Denial Memorandum

Applicant: David F. Salvaggio
Address: 32 Ridge Road, Rumson, NJ 07760
Block 62, Lot 25, Zone: NB/R-4

Proposed Residence
32 Ridge Road
Rumson, NJ 07760

As part of our application to the Zoning Board of Adjustment, find enclosed revised drawings addressing the Denial Memorandum and responses below:

2 PROPOSED SITE PLAN
SCALE: 1" = 10'-0"

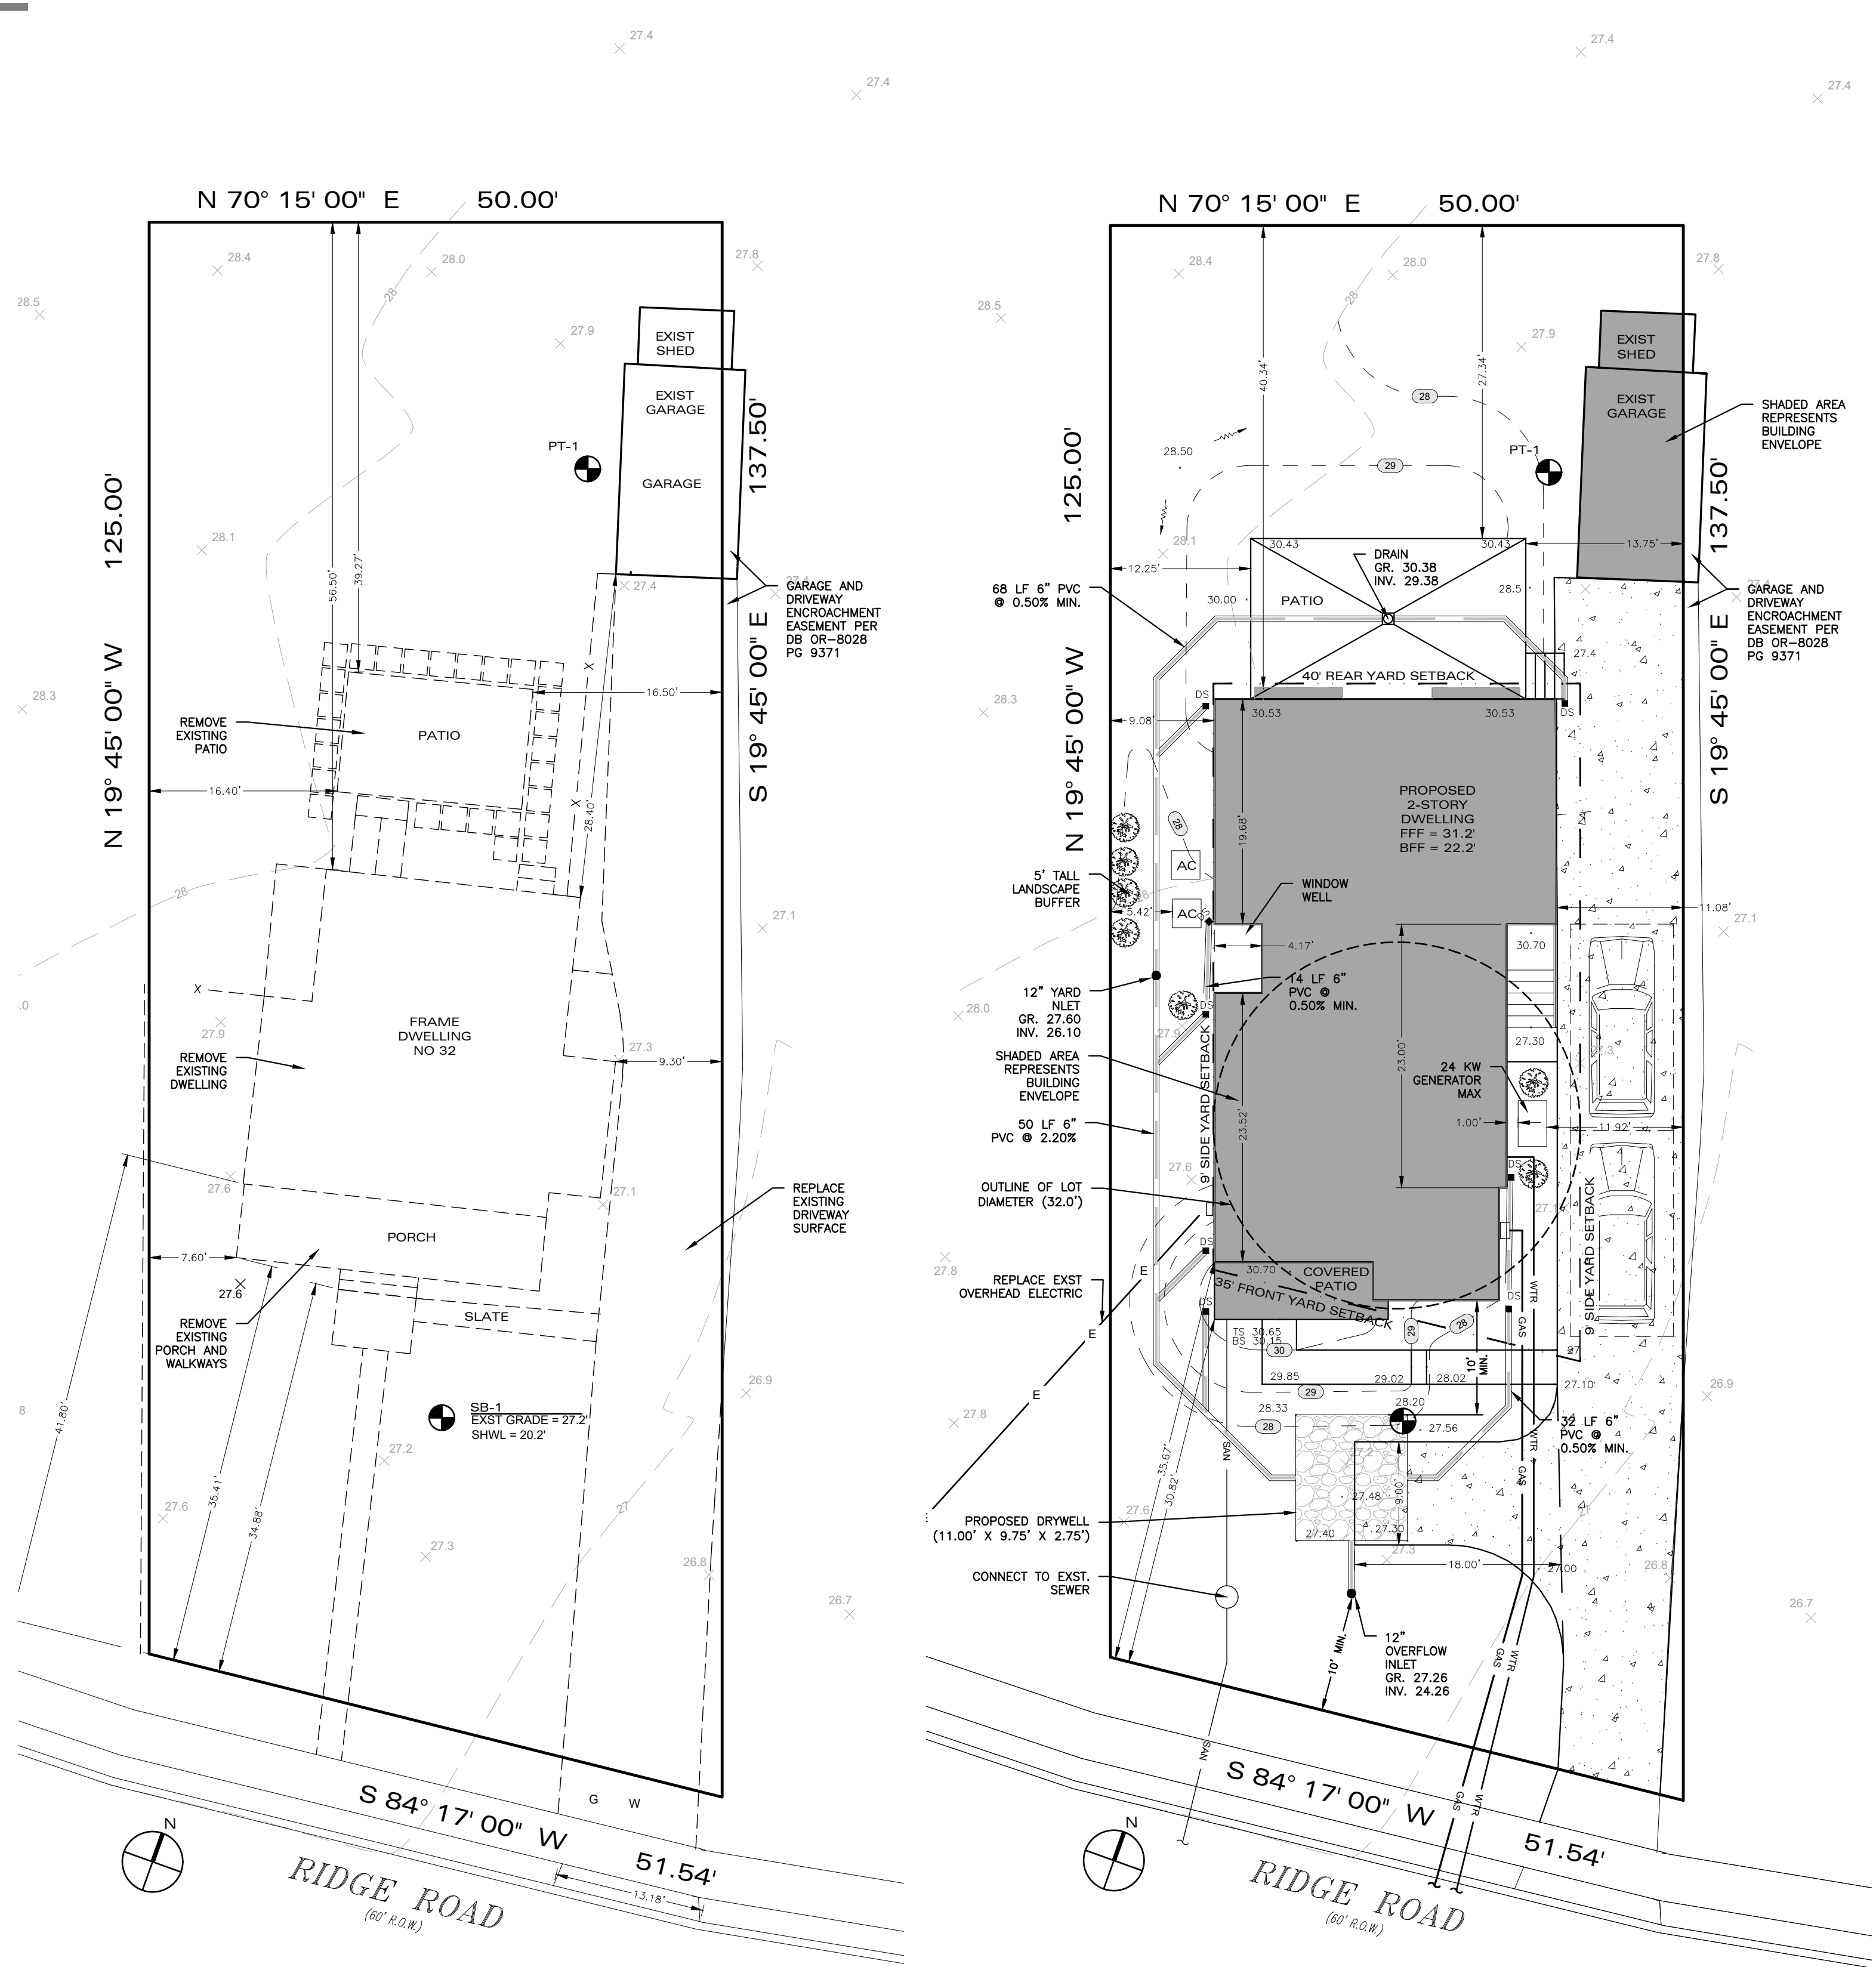
- (22-5.7b) No attached or detached garage is proposed, whereas an attached or detached garage is required.

- (22-7.26j) K-turns are permitted on properties with a single driveway that front on a Monmouth County Route. Given the proposed design, comment from the Borough Engineer is recommended regarding the maneuverability of the proposed K-turn configuration.

- Please add the note "24 kW Max" to the proposed generator location on the plans.

We are now proposing to leave the existing detached garage. The site plan has been updated accordingly.

The K-turn has been reconfigured for proper maneuverability.

This note has been added to the plot plan on C1.01.

7 ATTIC AREA DIAGRAM
SCALE: 1/8" = 1'-0"

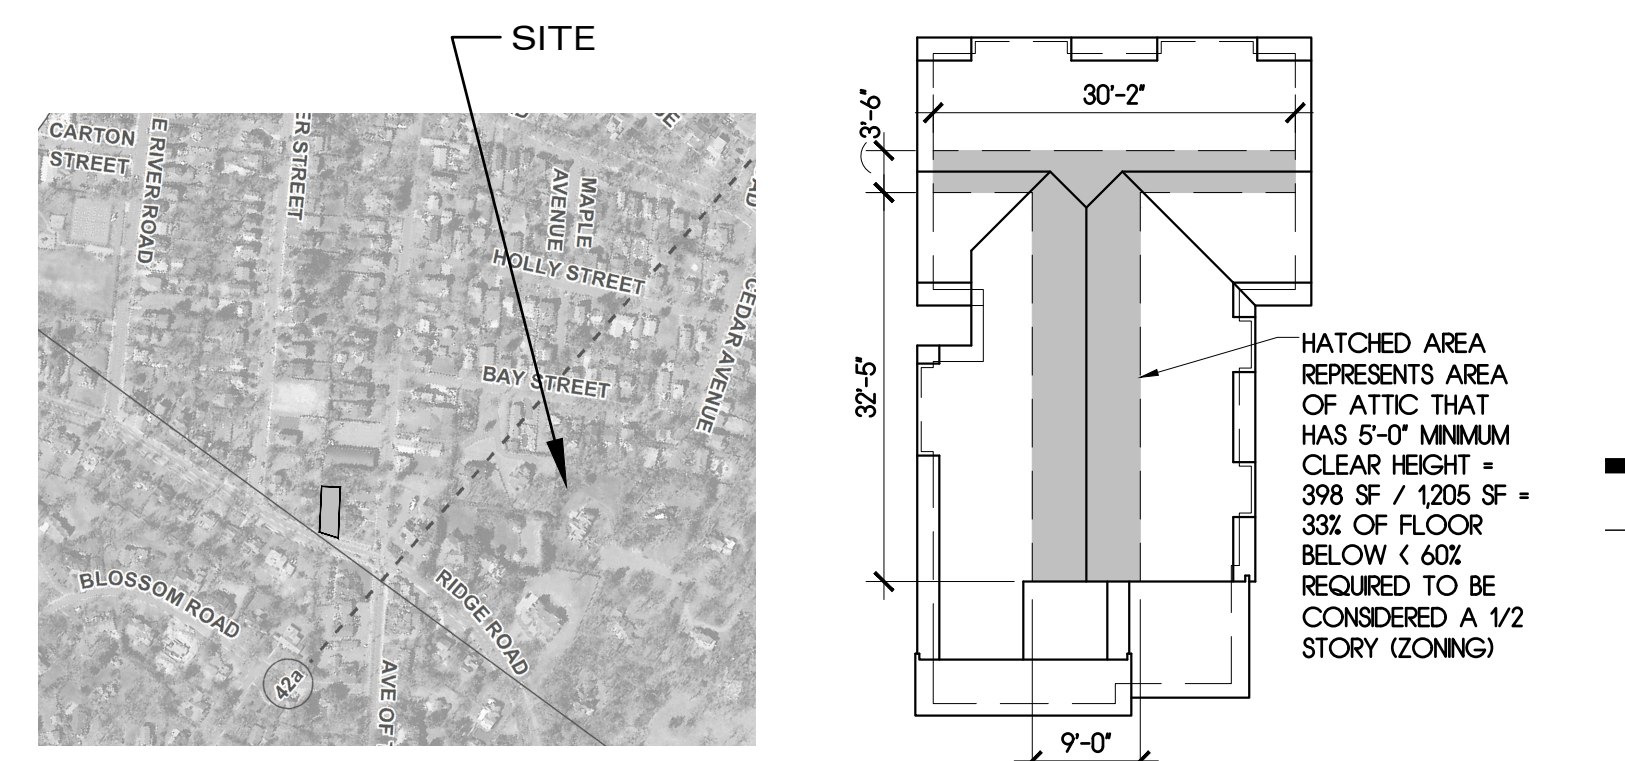
- The architectural plans do not adequately demonstrate compliance with the ordinance definition of a half-story. Specifically, the area of the attic having a ceiling height greater than five (5) feet above the attic floor does not exceed sixty percent (60%) of the floor area immediately below. The second-floor area is approximately 1,200 square feet and should be used to demonstrate compliance with the ordinance definition of a half-story.

An attic diagram showing the floor area with 5' clear height has been added to drawing C1.01. The project complies.
